Report of Dam Safety Assessment
Coal Combustion Surface Impoundments
Georgia Power
Plant Mitchell, Albany, GA

AMEC Project No. 3-2106-0174.0600

December 2010

GEORGIA POWER
PLANT MITCHELL, ALBANY, GA
ASH POND 2 INTERNAL DRAINAGE AND
SETTLEMENT MONUMENT LOCATIONS

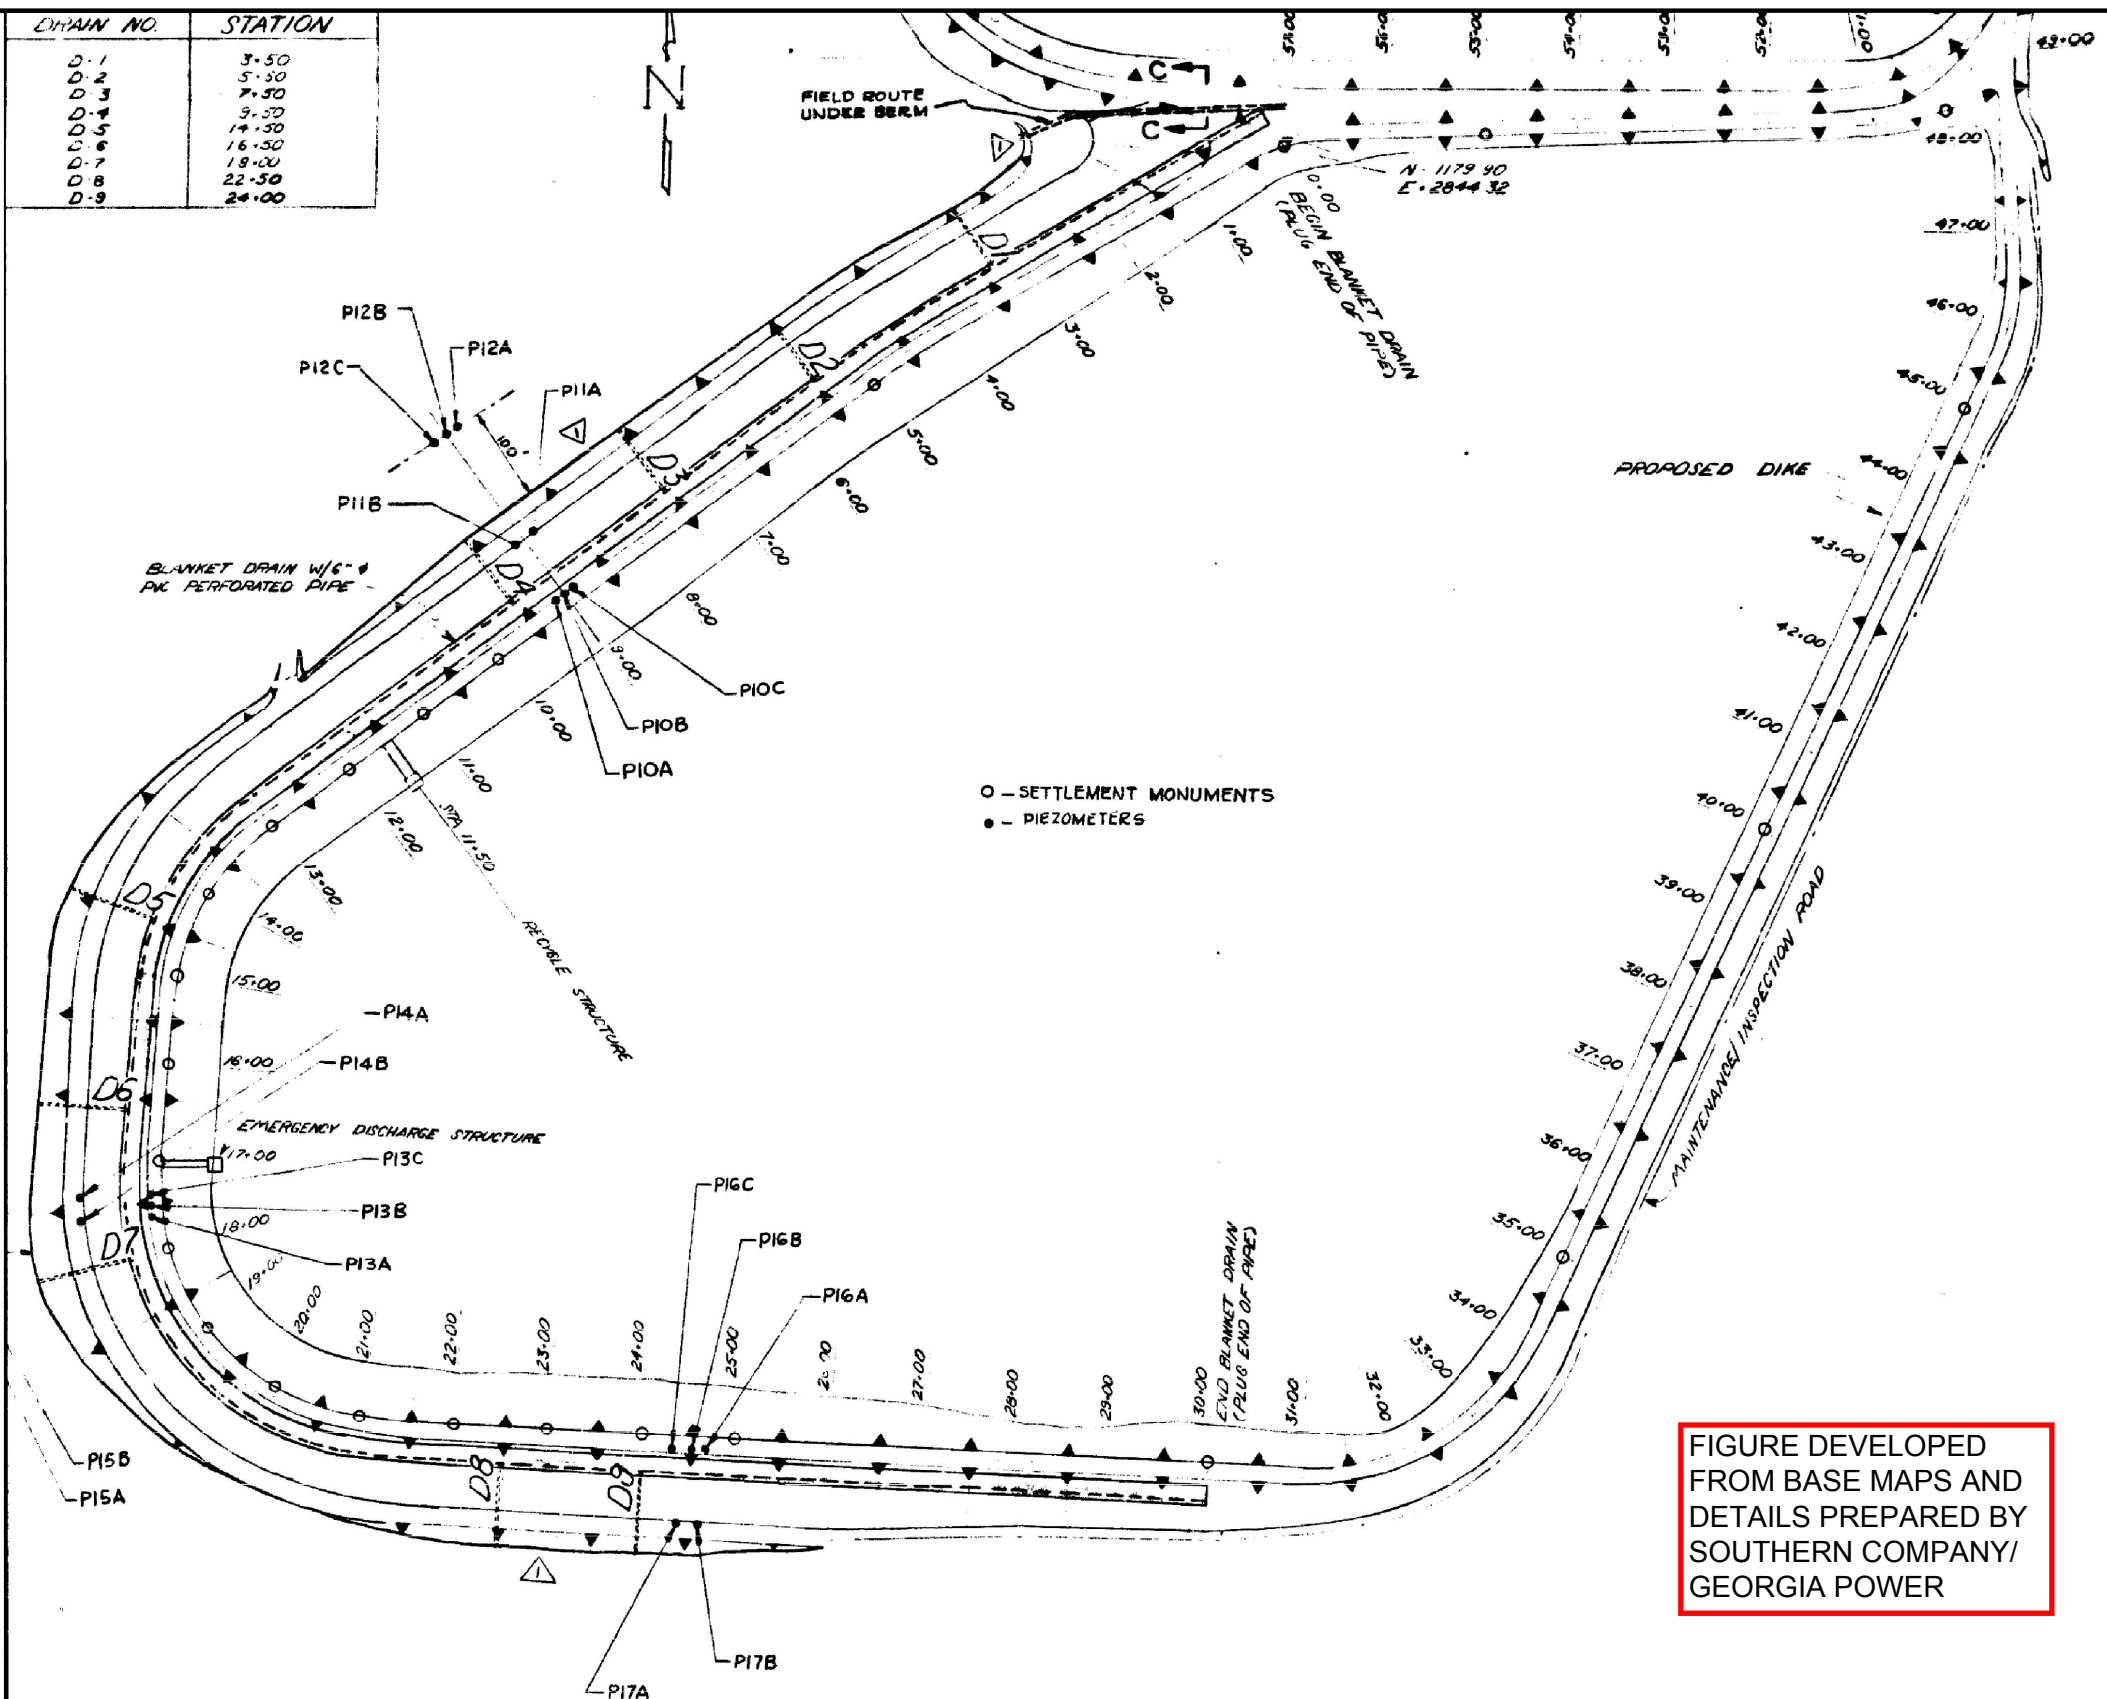
Internal blanket drains (MIT-API 0024), as illustrated on Figure 8, were installed in Ash Pond 2 just downstream of the dike's centerline and extend from Station 0+00 and Station 30+00. The blanket drain is 20 feet wide, 3 feet thick and is comprised of washed river sand. A 6-inch diameter slotted pipe with a 6-inch minimum cover of number 78 stone is embedded in the blanket drain. In addition, nine transverse finger drains are located in the topographic low areas along the dike alignment. Each finger drain, a 6-inch diameter slotted PE pipe encased in sand is slotted within the blanket drain region and solid outside the region. The finger drains are connected to the slotted pipe located within the blanket drain. The purpose of the finger drains is to collect additional seepage in the dike, as well as seepage from the blanket drainpipe, and convey the seepage to the downstream toe of the embankment. The seepage then follows a drainage ditch to culverts located beneath Radium Springs Road (Georgia Highway 3), finally discharging into the Flint River (photo 2-25). During the site inspection, slight flow was observed at finger Drain Outlet 8, which is located along the south side of the pond and flows year round according to on-site personnel (photo 2-24). Slight flow was also noted at Drain Outlet 2, which is located along the northwest side of Ash Pond 2 (photo 2-28). The remaining drains were not flowing (photos 2-6, 2-27, and 2-29).

TITLE
GEORGIA POWER
PLANT MITCHELL, ALBANY, GA
ASH POND 1 AND 2 2010 SLOBE STABILITY BORING AND PIEZOMETER
LOCATIONS

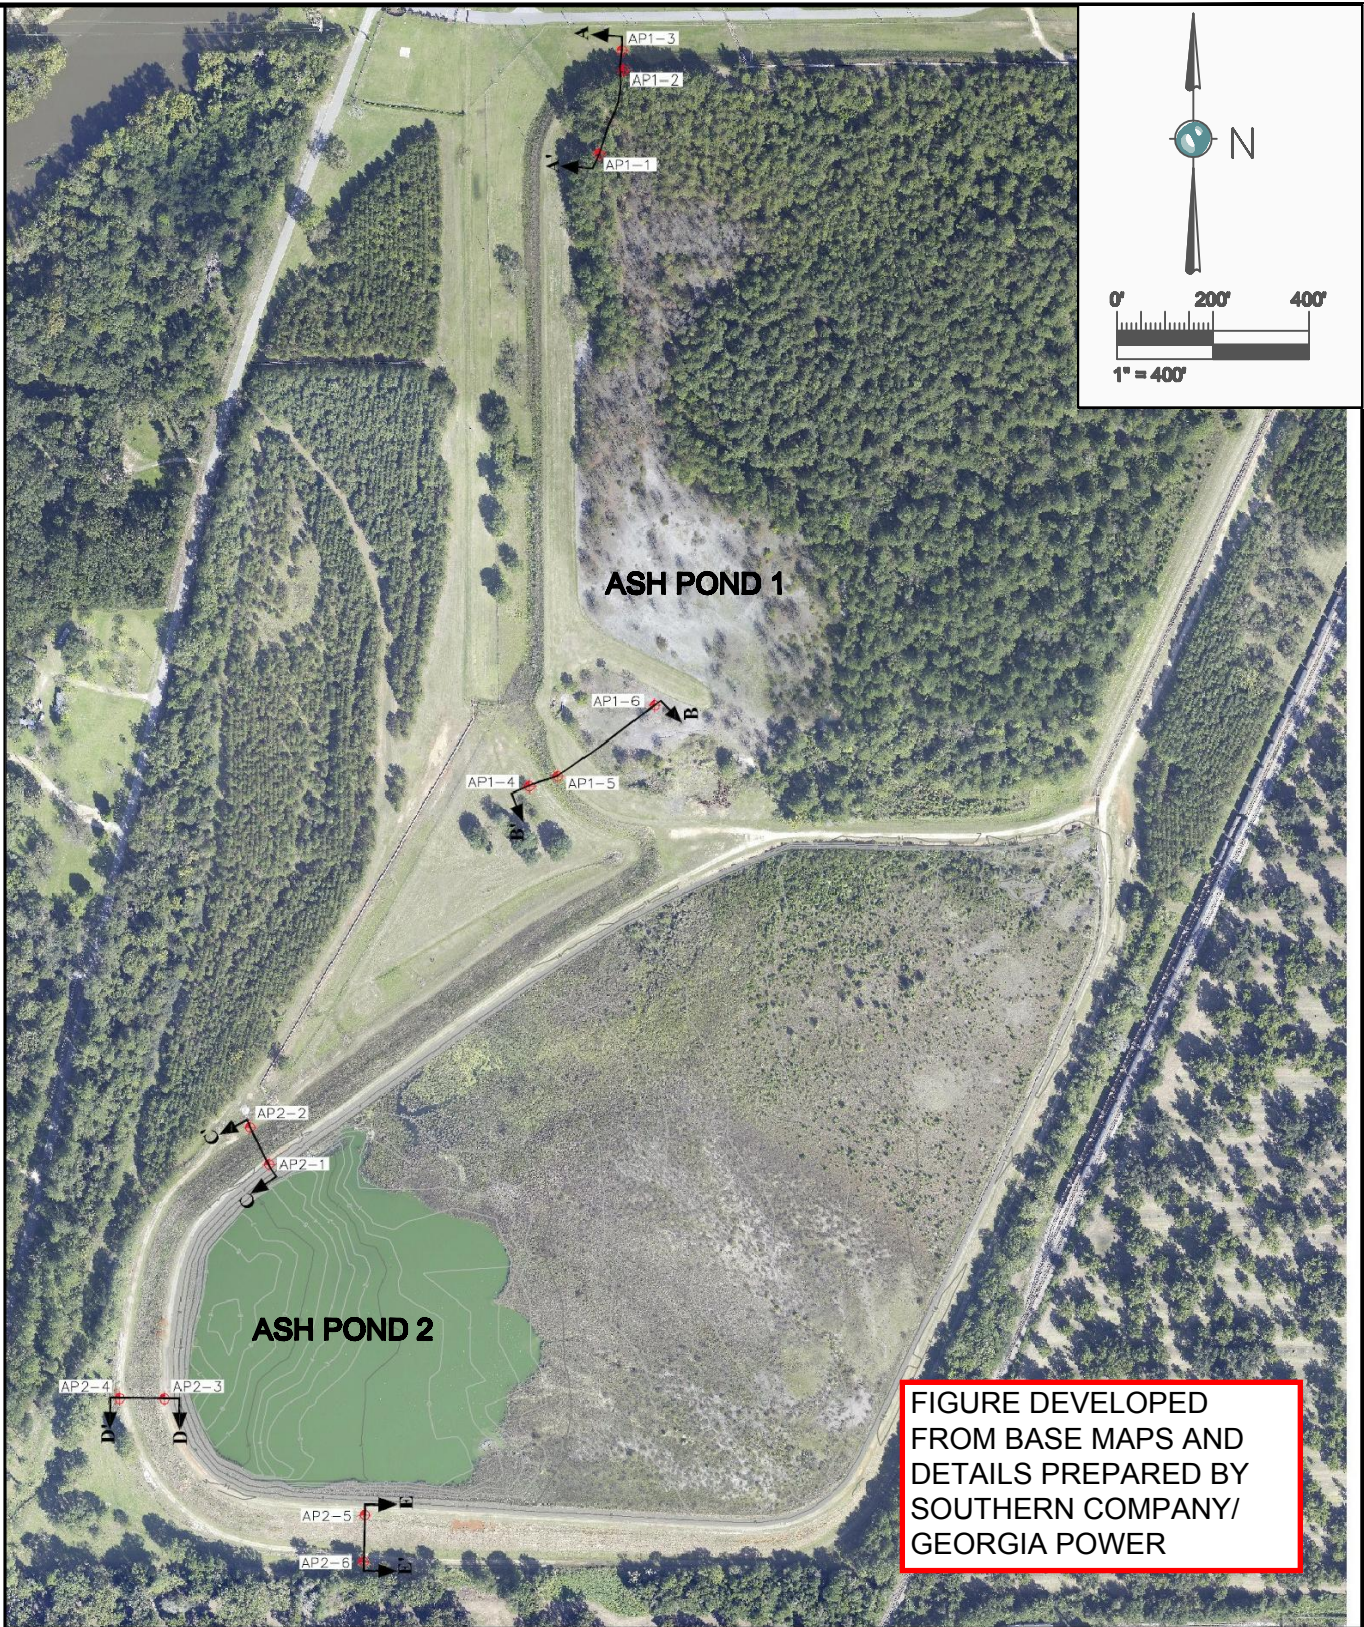
Cross sections modeled in the 2010 SCECS Stability Analyses are shown on Figure 9 of this assessment report. SCECS reported the following soil parameters utilized in the analyses for Ash Ponds 1 and 2, as shown in Table 10.

In response to the recommendations regarding the failure surface optimization and utilization of different analyses that AMEC provided in the Draft Report, additional documentation, provided by SCECS, reported computed factors of safety for various slope stability failure conditions as listed in Table 11. All failure conditions are steady state, except where noted. Finally, all resulting SCECS calculated factors of safety indicate that Ash Pond 1, as well as Ash Pond 2, are stable.
